CITY OF WICHITA

Re: **BZA2010-00043: City Administrative Adjustment City to reduce the setback (compatibility setback and interior side setback) to four feet on the west property line and to reduce parking requirement by up to 20 percent on property zoned LC Limited Commercial.**

Legal Description: Lot12, Block 1, Wilbers Addition, Wichita, Sedgwick County, Kansas; generally located generally located on the northwest corner of 21st Street North and Piatt Avenue.

SITE PLAN
BZA2010-00043

SITE LAYOUT & UTILITY PLAN
C2.1
SHEET

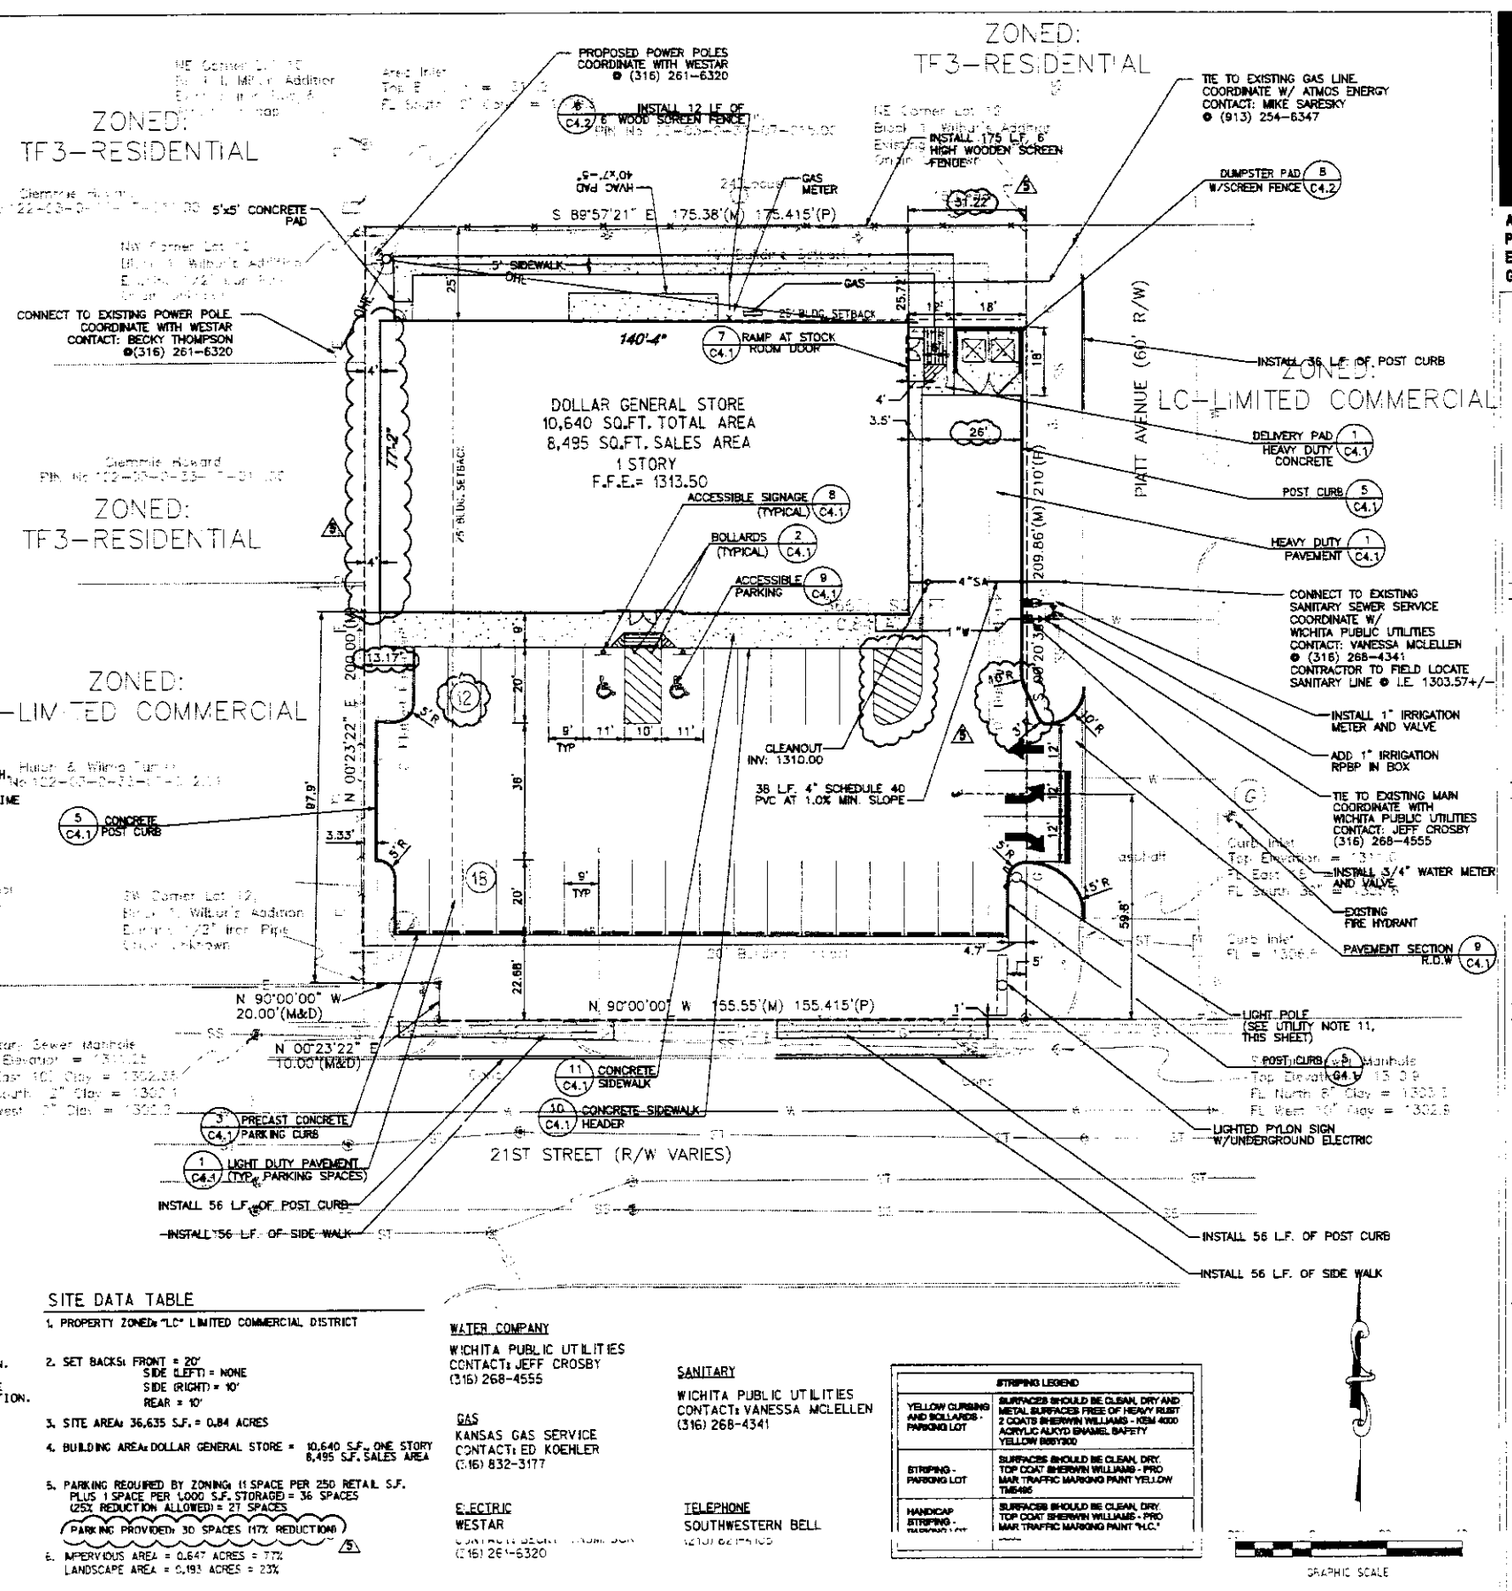
We have reviewed your request for an Administrative Adjustment to reduce the setback (compatibility setback adjacent to TF-3 Two-Family Residential ("TF-3") zoned property and interior side setback for west property line) to four feet AND to reduce parking requirements for the aforementioned property zoned LC Limited Commercial ("LC"). You have stated that a new retail building is being constructed on the tract. The site, utilized to its fullest, can provide approximately 30 of the 36 parking space requirement.

The Unified Zoning Code allows an Administrative Adjustment to reduce parking requirements by up to 10 percent for any new project, or up to 25 percent for redevelopment of existing sites, when documented that it meets the adjustment criteria. The provided site plan shows a 17 percent reduction.

The adjustment would reduce the interior side setback for the west property line by 20 percent and the compatibility setback adjacent to TF-3 zoned property from 25 feet to four feet.

We find that reducing the interior side setback and compatibility setback and the required parking up this level, rounded to 20 percent, on the aforementioned property meets the four conditions required by Section V-I.6 of the Unified Zoning Code as set out below:

1) Impact on safety and convenience of vehicular and pedestrian circulation: The reduced side setback does not encroach on streets or sidewalks. The 20 percent reduction in parking requirement will allow the maximum utilization of the site, without encroaching onto the right-of-way and providing required traffic circulation and drive aisle widths. Therefore, the adjustments should not impact the safety and convenience of vehicular and pedestrian circulation.

2) Impact on existing uses in surrounding areas: Two residential lots zoned TF-3 abut the north half of the west property line. The nbrthernmost lot has a large garage on its rear, blocking its view of the commercial building. On the other lot, the back yard abuts the interior side yard. The view from the back of the house will be toward the side façade of the commercial building. The building façade will, however, screen the view of customers coming and going from the business. Regarding the parking reduction, sufficient parking still should be provided on site to meet the parking needs of the business. Additional on-street parking along Piatt Avenue, with commercial zoning on both sides of the street, offers as many parallel parking spaces as on-site parking spaces are eliminated by the adjustment. The redevelopment of the site should be a positive impact on the nearby commercial corridor.

3) Compatibility with existing or permitted uses on abutting sites: Compatibility setbacks can be reduced or even eliminated, if it is deemed appropriate. Interior side setbacks on LC zoning are set at zero feet or five feet, eligible for a 20 percent administrative reduction or four feet. When two commercial uses are abutting, a zero setback may be appropriate. In this case where abutting a residential use, it was determined that a setback needed to be provided to allow a narrow strip of landscape plantings; to break the visual mass of the commercial building from the residence. Therefore, the interior setback was reduced by 20 percent to four feet, but maintained in this narrow form so as to allow the landscape planting to soften the view from the residence. The reduction in parking requirements is within allowable adjustments. The proposed use is permitted by right by the LC zoning and keeps the parking is kept toward the commercial (21st Street North) edge of the site.

4) Effect on public health, safety or welfare: There will be no encroachment into public utility easements or right-of-way, therefore, there should not be a negative impact on the public health, safety or welfare nor will properties or improvements in the vicinity be materially injured.

Our signatures below indicate that an Administrative Adjustment to reduce the compatibility setback and interior side setback to four feet on the west property line AND to allow a reduction in the parking requirements by up to 20 percent for the aforementioned property is hereby granted, subject to the following conditions:

1) The site shall be developed in general conformance with the approved site plan and Landscape Plan, with special attention to selecting plants that suitable for breaking the visual mass of the building abutting the TF-3 zoned property.

2) The parking area shall be paved and marked in accordance with the site plan.

3) Any violation of these conditions shall render the Administrative Adjustment null and void.
